Planning Commission Meeting

Thursday, January 12, 2017

Site Plan & Conditional Use Permit (CUP)

ABC Great Beginnings

SITE PLAN - OVERALL
SIGN PLACEMENT AND
UDOT NOTES

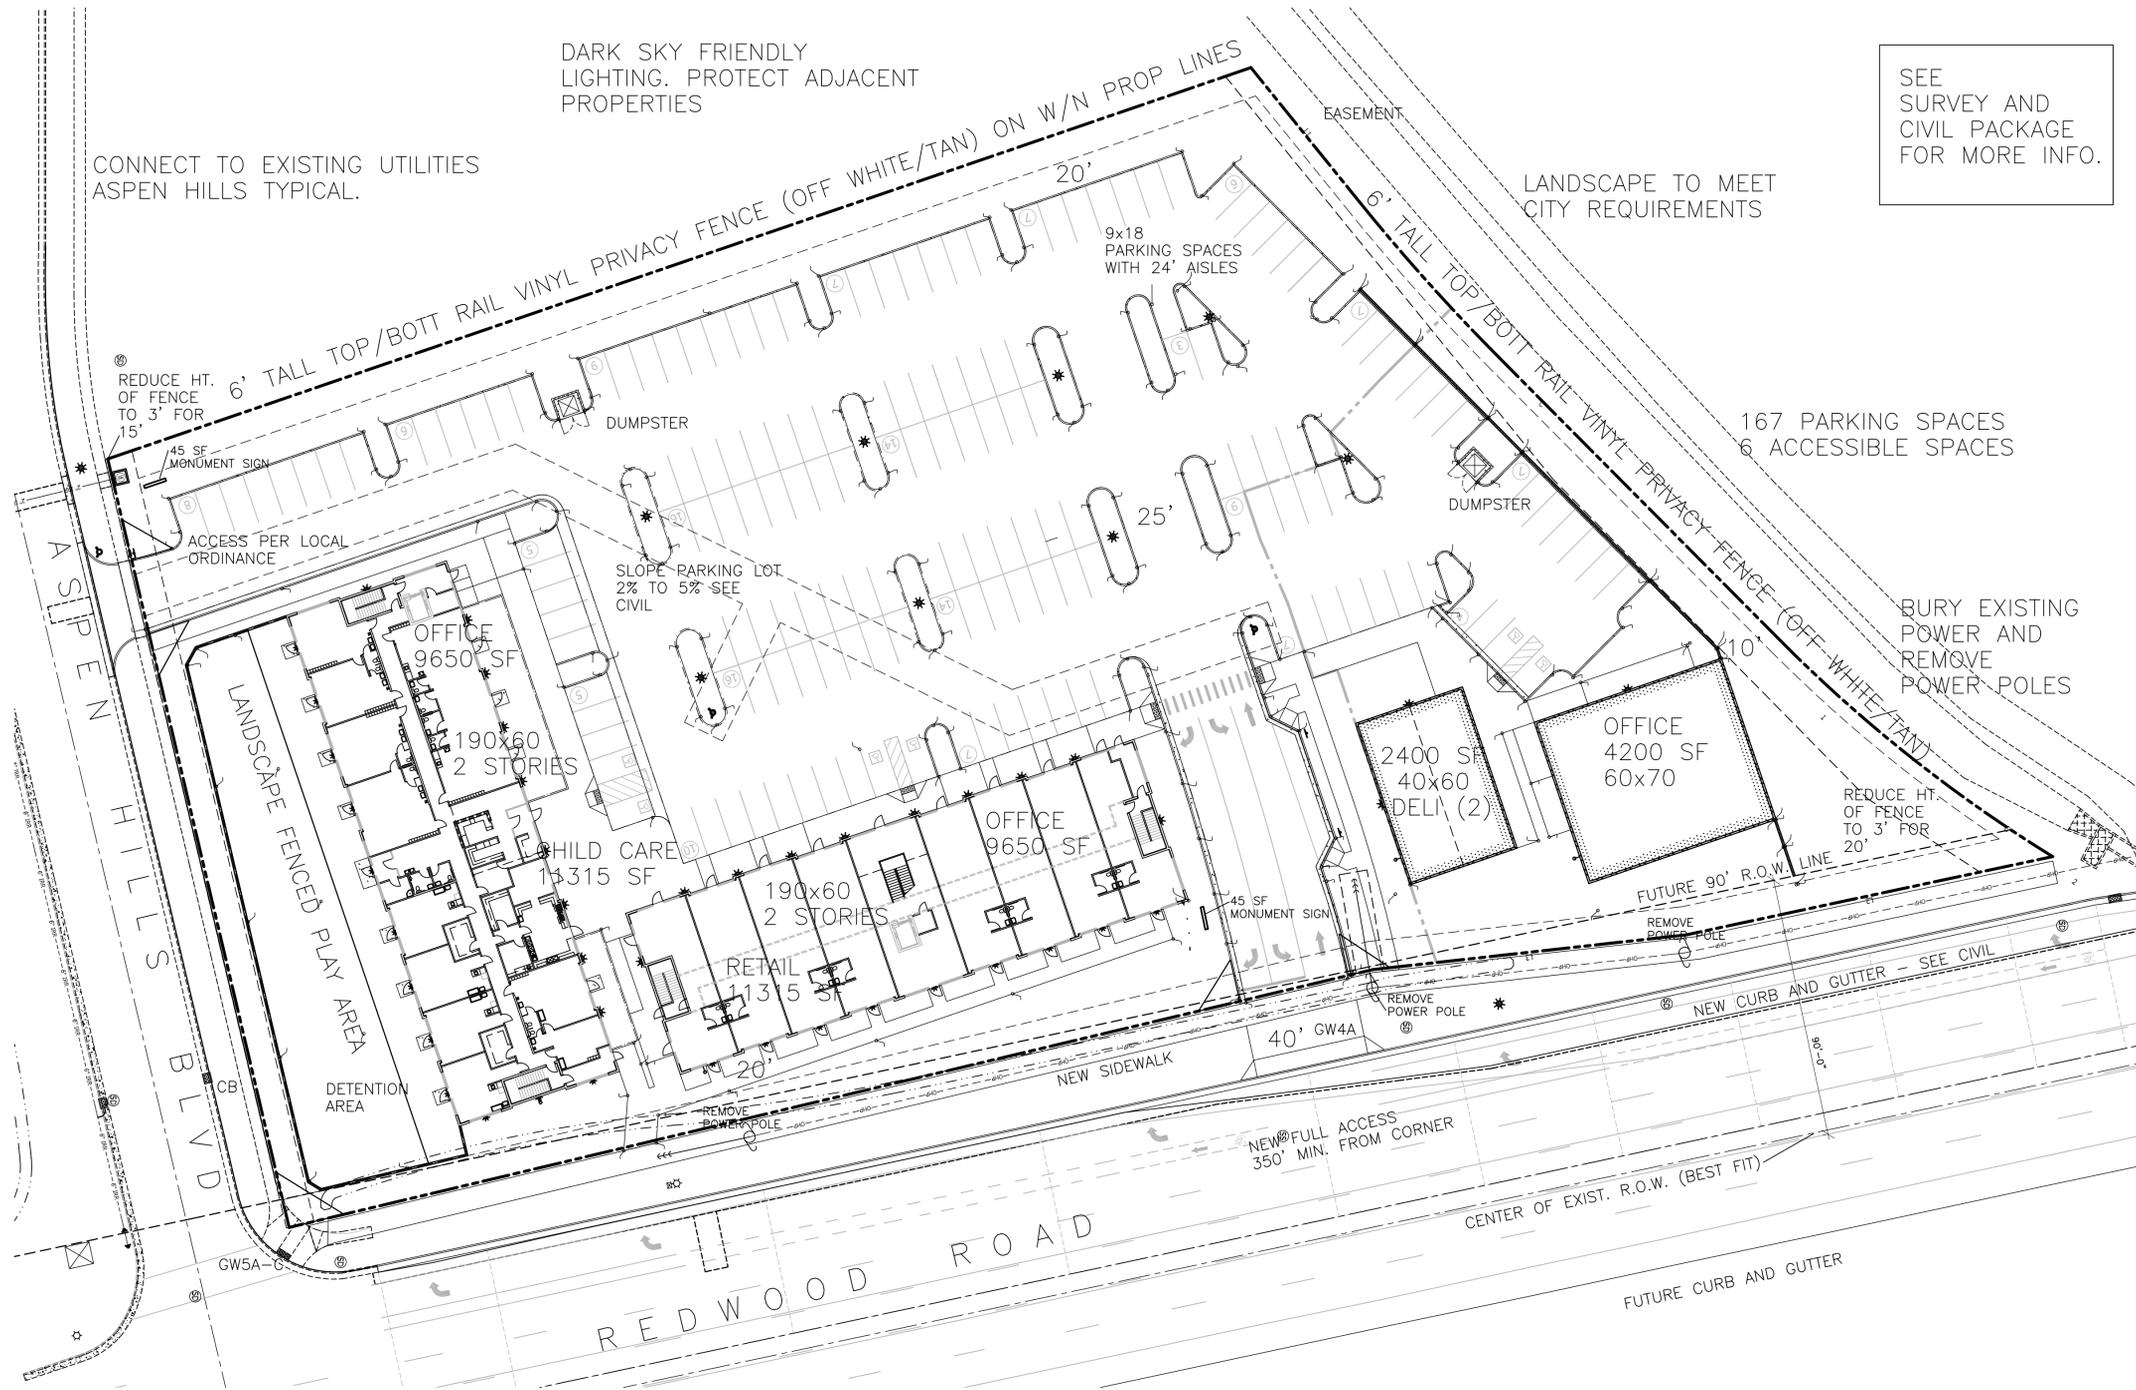
- A 6' tall opaque wall or fence shall be installed and maintained along lot lines abutting residential zones. Residential zones lie to the north and west of the proposed development. A 6' tall off white/tan vinyl privacy fence is called out on the Architectural site plan, but no detail has been provided.

- 19.11, Lighting: Complies, if conditions No. 10 & 11 are met
 - Parking lot poles: Detail must be provided.
 - Sign illumination has been requested, but none has been received.

- 5. Sprinkler heads shall be water-conserving.
- 6. A detail for the proposed 6’ tall vinyl privacy fence shall be provided.
- 7. The northern end double parking lot island shall measure approximately 280 sq. ft. in size or 36’ x 9’.

- 10. A parking lot pole detail shall be provided and the pole shall comply with Section 19.11.
- 11. All outdoor sign lighting shall comply with Section 19.11 and 19.18.

3 TREE PLANTING 1'-1'-0"

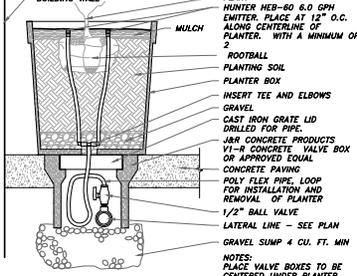
- Tree Base Clearance: Complies. 3’ clearance free of rock and turf required. Note placed on detail 3.
 - Shrubs: Complies. 25% shall be 5 gallon and the rest shall be 1 gallon. Complies. 25% of the required shrubs are 5 gallon and the rest are 1 gallon.
